# JWM90A & JWM92A HDMI Changes

Revision Specific

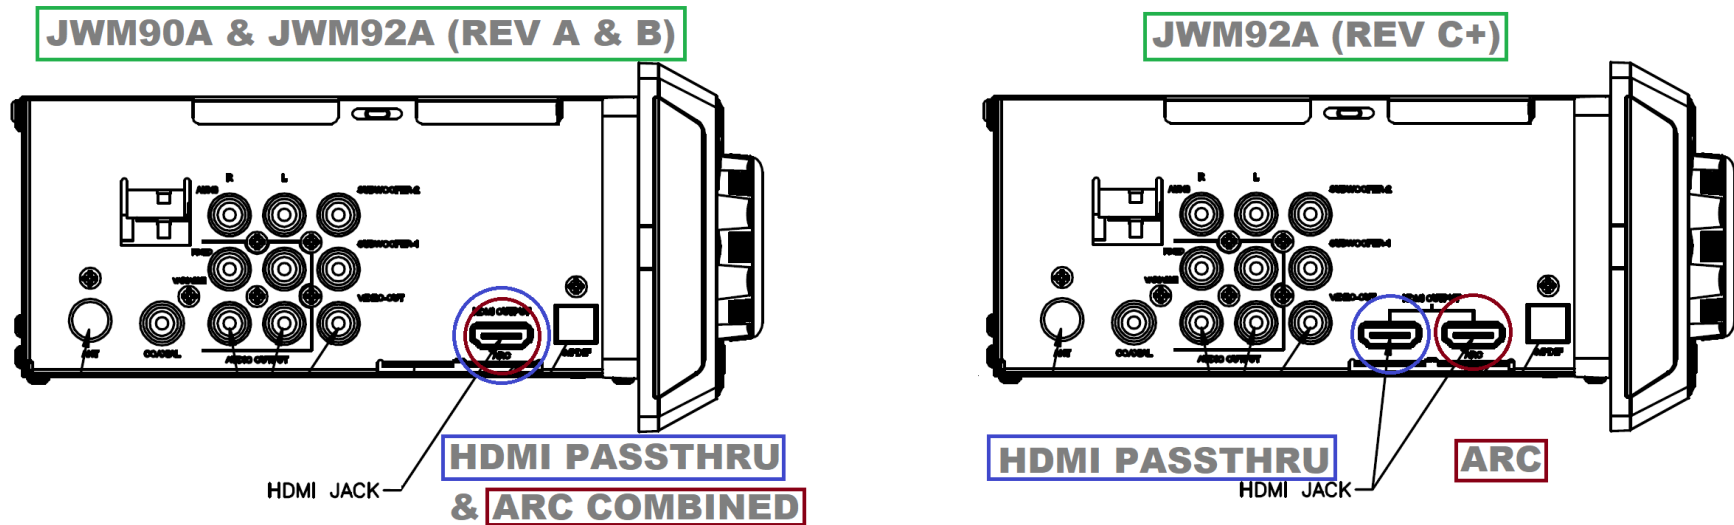
- JWM90A & JWM92A (Rev A & B) have a single HDMI port combination which supports HDMI ARC and HDMI Passthru
- JWM92A (Rev C & newer) has a **two** HDMI ports, one to support ARC, and another to support Passthru
- User may complain of no ARC function and could be caused by HDMI plugged into **non-ARC HDMI port** on JWM92A Rev C & newer
- If replacing JWM90A or JWM92A (Rev A & B) with JWM92A (Rev C & newer), user may need to run additional HDMI cable if using ARC and HDMI Passthru.
